SANTA MONICA MOUNTAINS CONSERVANCY

October 17, 2022

**Draft Project Environmental Impact Report/Environmental Impact
Statement for the Palmdale to Burbank Section of the
California High-Speed Rail (SCH 2014071074)**

CALIFORNIA HIGH-SPEED RAIL AUTHORITY - PALMDALE TO BURBANK PROJECT
 SR14A Spring and Bee Canyons Map

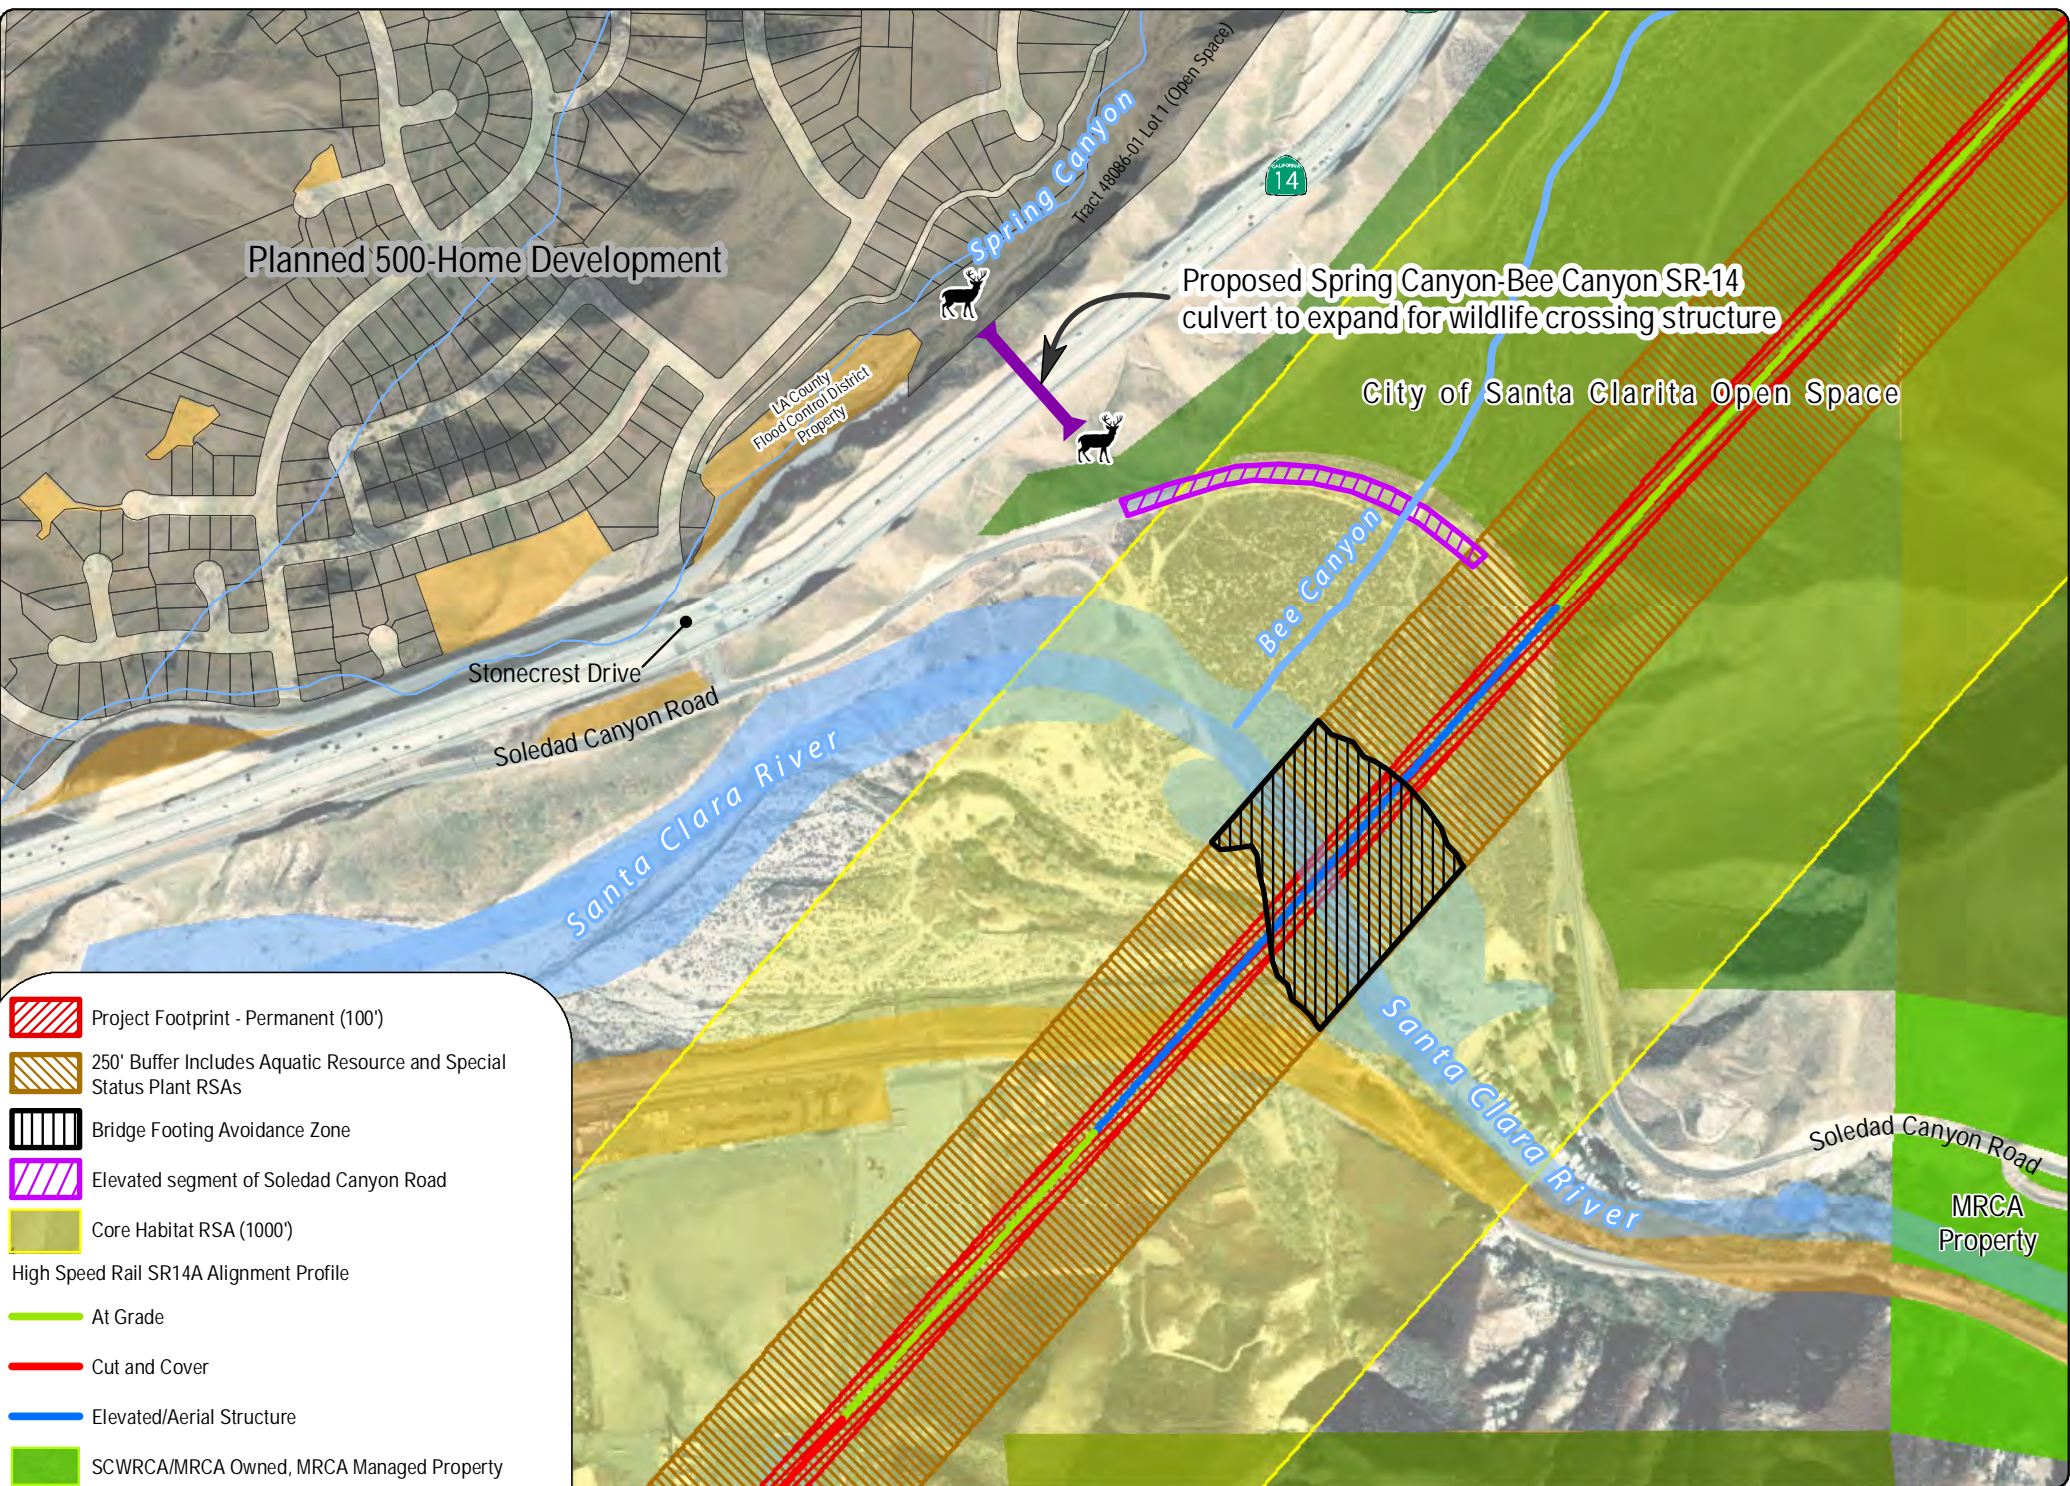
Mitigation Measure No. 1: Construct a new SR-14 wildlife undercrossing between the Spring Canyon Tract No. 48086-01 dedicated open space and City of Santa Clarita-owned Bee Canyon open space. This undercrossing should be a bored tunnel with a minimum 13-foot diameter and would not require any cut and over freeway traffic disruption. See Attachment D – SR14A Spring and Bee Canyons Map with proposed undercrossing location. Construction access to the east tunnel entrance area is excellent. The nexus for this additional mitigation measure follows below.

Mitigation Measure No. 2: Minimize HSR bridge footings within the Santa Clara River floodplain.

change impacts. Near this same location, ephemeral Bee Creek joins the Santa Clara River and is, per Figure 3.8-A-47 (SR14A Central Subsection (Center) Surface Water Callout), designated as Federal Emergency Management Agency (FEMA) Special Flood Hazard Area Zone A. The Conservancy recommends that bridge span design place footings as far as feasible from the Santa Clara River active channel and outside FEMA Zone A Special Flood Hazard Area to minimize construction and operational disturbances to this vital water resource and wildlife corridor. See Attachment D – SR14A Spring and Bee Canyons Map for the Bridge Footing Avoidance Zone.

Mitigation Measure No. 4: Elevate Soledad Canyon Road at the convergence of Bee Canyon and Soledad Canyon with new, large-dimension box culverts or arch spans for wildlife permeability and to restore prior hydrology potential.
